**SUBDIVISION REVIEW SHEET****CASE NO.:** C8-2021-0152**COMMISSION DATE:** August 16, 2021**SUBDIVISION NAME:** Pinnacle at Wildhorse Ranch Preliminary Plan**ADDRESS:** 12000 Blue Bluff Rd**APPLICANT:** Texas WH200 LP**AGENT:** Kimley-Horn and Associates (Kevin Burks)**ZONING:** Wildhorse Ranch PUD**NEIGHBORHOOD PLAN:** Wildhorse Ranch PUD**AREA:** 60.06 acres**LOTS:** 57**COUNTY:** Travis**DISTRICT:** 1**WATERSHED:** Gilleland Creek**JURISDICTION:** Full Purpose**SIDEWALKS:** Sidewalks will be constructed along all internal streets and the subdivision side of Blue Bluff Road.**VARIANCES:** Variances from LDC § 25-8-341, to allow cut over four feet, and LDC § 25-8-342, to allow fill over four feet.**DEPARTMENT COMMENTS:**

**CITY OF AUSTIN – TRAVIS COUNTY – SINGLE SUBDIVISION OFFICE  
SUBDIVISION APPLICATION – MASTER COMMENT REPORT**

CASE NUMBER: C8-2021-0152  
 REVISION #: 00  
 CASE MANAGER: Jennifer Bennett  
 UPDATE: U0  
 PHONE #: 512-974-9002

PROJECT NAME: Pinnacle at Wildhorse Ranch  
 LOCATION: 12000 BLUE BLUFF RD

VICINITY MAP  
SCALE: 1" = 2,000'

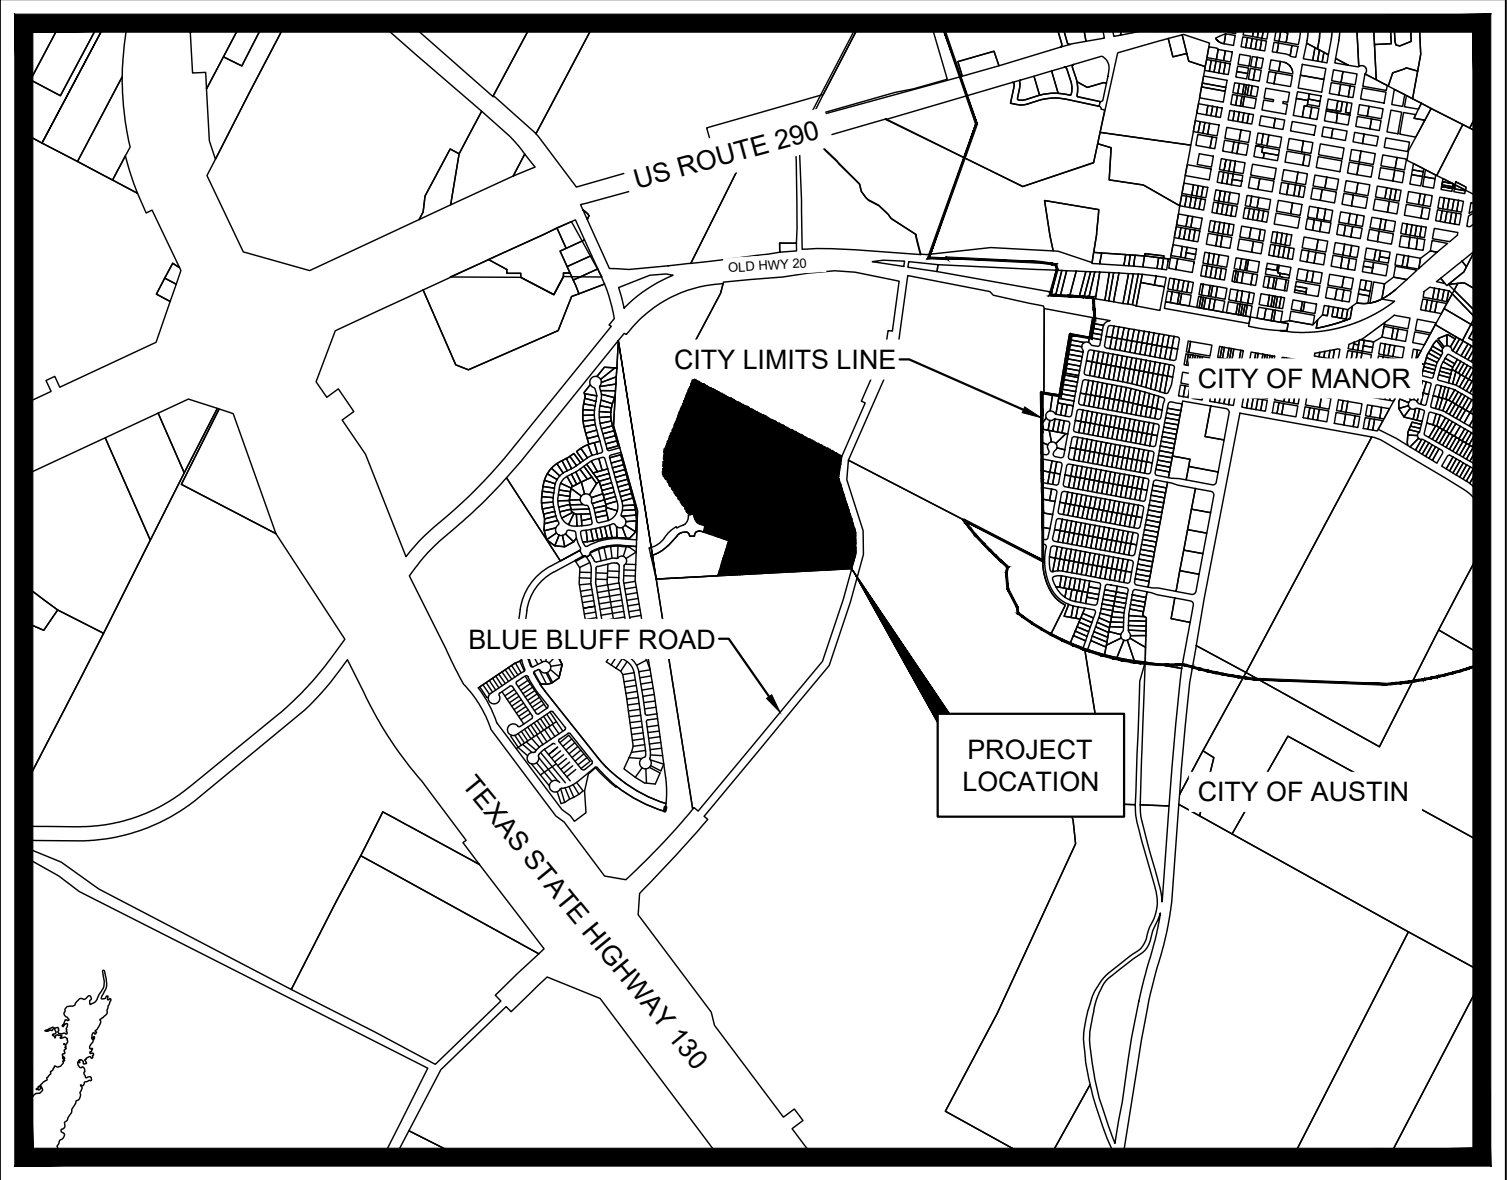
AD2: In the vicinity map, update the label for E US 290 HWY SVRD EB as it reads here.

AD3: In the vicinity map, update the label for N SH 130 NB as it reads here.

AD6: Add the label for E PARMER LN as it reads here.

COVER SHEET

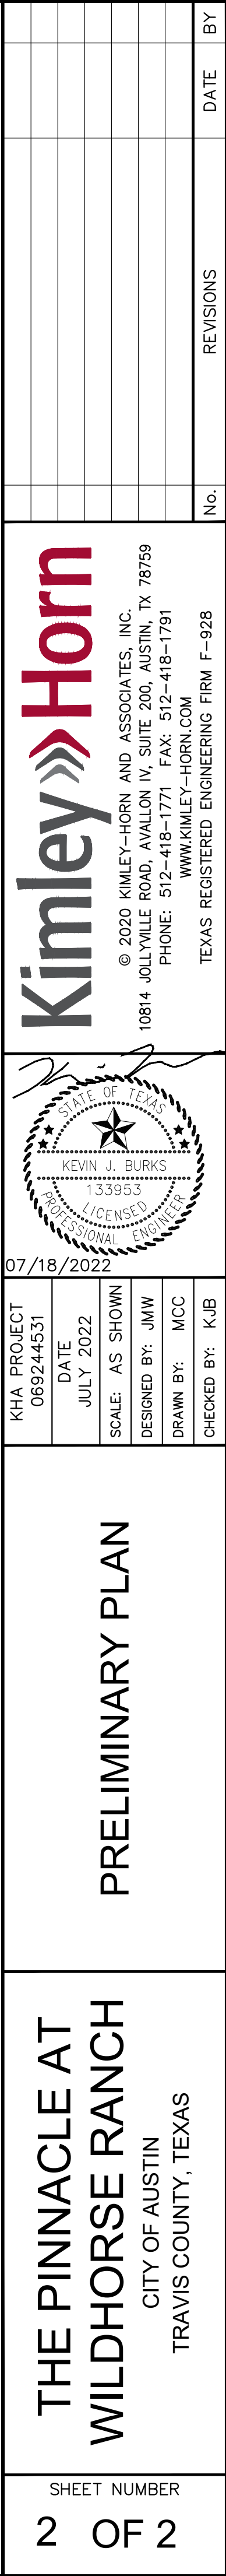
EV 5 Please revise the cover sheet variance note as follows:

- SR 1. This application was submitted on July 18, 2022. All comments must be cleared by October 17, 2022. (LDC § 25-1-83)
- SR 2. Per TCAD, this property appears to be owned by Texas WH200 LP with the most recent deed recorded in Document No. 2010177691. Please update the preliminary plan application with the ownership information and have the correct owner sign the application. Also, the owner's information should be updated on Sheet 1 of the prelim. (LDC § 25-1-83)

- SR 3. Revise the Case # (C8-2021-0152) in the bottom right-hand corner of each sheet to leave off "PA". (LDC § 25-1-83)
- SR 4. Double-check all of the Lot and Block numbers. There appear to be like 3 "Lot 1, Block A" lots with the same label. (LDC § 25-1-83)

- A LAND USE COMMISSION ENVIRONMENTAL VARIANCE TO 25-8-341 TO ALLOW CUT TO 15 FEET WAS GRANTED BY THE ZONING AND PLATTING COMMISSION ON \_\_\_\_\_.
- A LAND USE COMMISSION ENVIRONMENTAL VARIANCE TO 25-8-342 TO ALLOW FILL TO 15 FEET WAS GRANTED BY THE ZONING AND PLATTING COMMISSION ON \_\_\_\_\_.
